Flight Procedure Tracking Form		Action: FLIGHT CHECK	Task Type: IAP	Date Open: 08/18/2017	Task #: 2014090928737502001	Request #: 20140909287375
Procedure: RNAV (GPS) Y RWY 35 ORIG			Airport ID: KVEL	Airport: VERNAL RGNL		Reimbursable #: NO
City: VERNAL	ST: UT	GPS #:	Estimated Chart Date: 12/07/2017		FICO #:	
Fac ID: N/A		Fac. Type:		Specialist: COLTON CROWDER		
Procedure Review						
	Rec'd	Rel'd	Full Name	Comments		
Lead:	08/19/2016	10/13/2017	TRACEY STILES	QUALITY		
QA:	10/13/2017	10/13/2017	TRACEY STILES	4	10/24CTabaka	
Liaison:	10/13/2017	10/16/2017	MARY MCDONALD	CHECKED		
Procedure Comments:			ENROUTE-NON			
			Remark Type: INFORMATION			
HARD DATE: AIRPORT MAGVAR CHANGED FROM 13E TO 10E AND RUNWAY NUMBERS CHANGED ACCORDINGLY.						
PENDING AIRPORT DATA USED.						
CONTACT PAT MULQUEEN: 405.954.4073						
10/13/17: THIS IS A CORRECTED COPY OF THE FORMS APPROVED ON 09/08/2017 CHANGED TERMINAL ROUTE VEL VOR/DME TO OHAPE FROM (FB) TO (FO). UPDATED ARINC CODE TO REFLECT CHANGE

RNAV (GPS) Y RWY 35
VERNAL RGNL (VEL)

**RNAV (GPS) Y RUNWAY 35, AMDT 2
RNAV (GPS) Z RUNWAY 35, ORIG
VOR RUNWAY 35, AMDT 9
TEXTUAL DEPARTURE, AMDT 2**

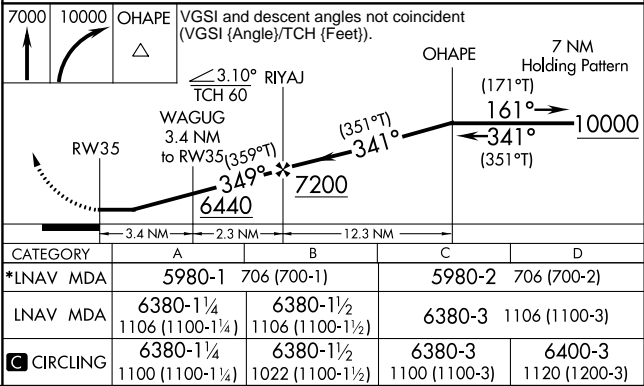
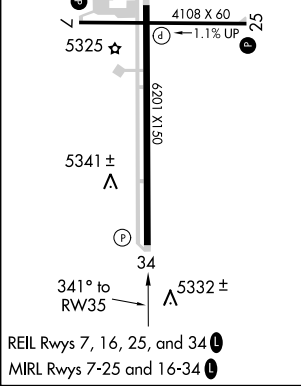
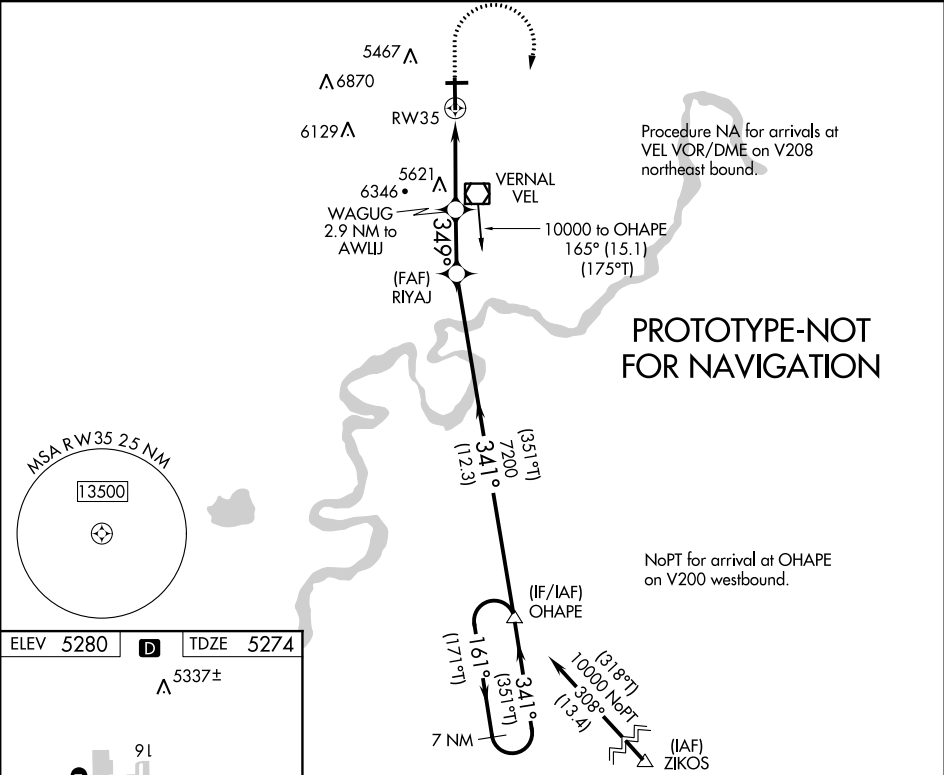
10/23/2017: THIS IS A CORRECTED COPY OF THE FORMS APPROVED ON 10/13/2017. 1. TERMINAL ROUTES, ZIKOS TO OHAPE: ADDED "(NOPT)" AFTER "OHAPE" IN ZIKOS TO OHAPE INITIAL SEGMENT.

RNAV (GPS) RWY 34

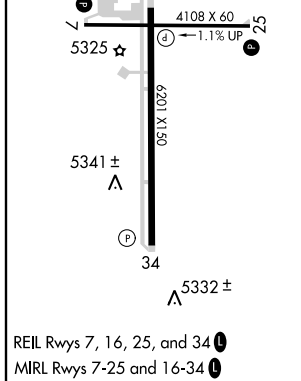
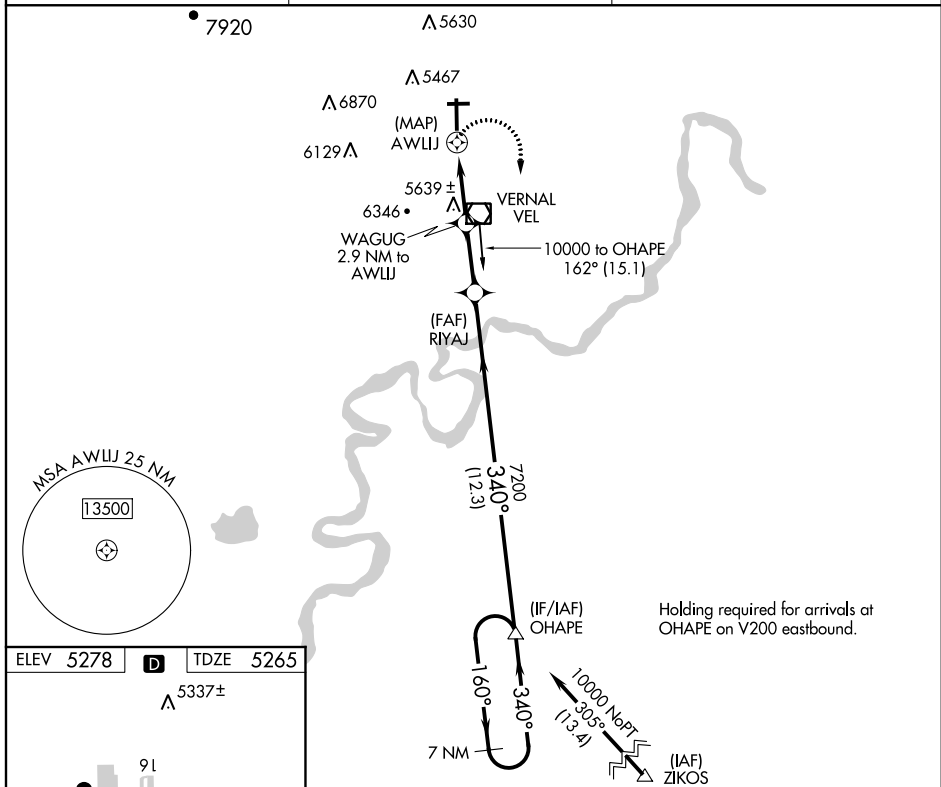
The published RNAV (GPS) RWY 34 procedure will be amended and renamed to become RNAV (GPS) Y RWY 35 (AMDT 2) and will be a Localizer Performance without Vertical Guidance (LP) and Lateral Navigation (LNAV) approach procedure. The existing fix WAGUG will move southwest approximately 4,835.96 feet and the altitude will be increased from 6,380 feet above mean sea level (AMSL) to 6,500 feet AMSL. An additional stepdown will be added. Climb gradient lines of minima will be added for the Missed Approach (MA).

For both procedures, fix RIYAJ will move southwest approximately 5,049.22 feet.
